MIL-C-6458C
AMENDMENT 6

CHAIN ASSEMBLIES, SINGLE LEG, AIRCRAFT CARGO TIE DOWN

This amendment forms a part of Military Specification MIL-C-6458C, dated 8 June 1966, and is approved for use by all Departments and Agencies of the Department of Defense.

FIGURE 1. GRAB HOOK

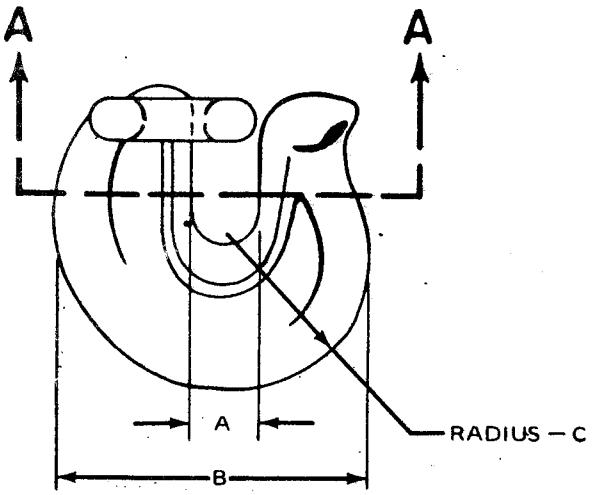
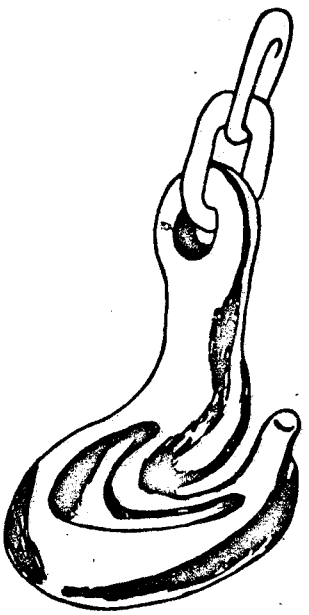
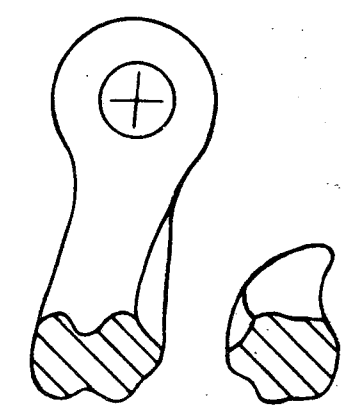
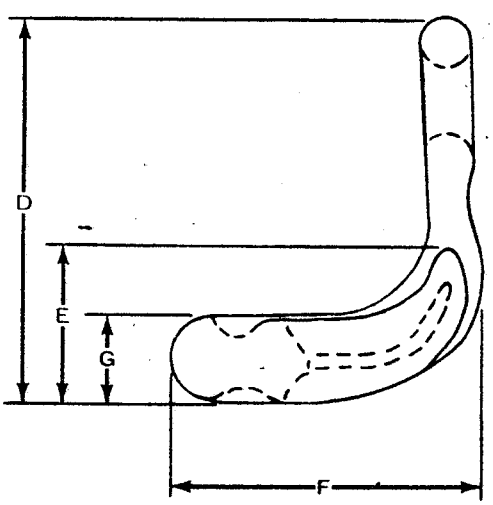
Figure 1: Delete and substitute new Figure 1 which forms page 4 of this amendment.
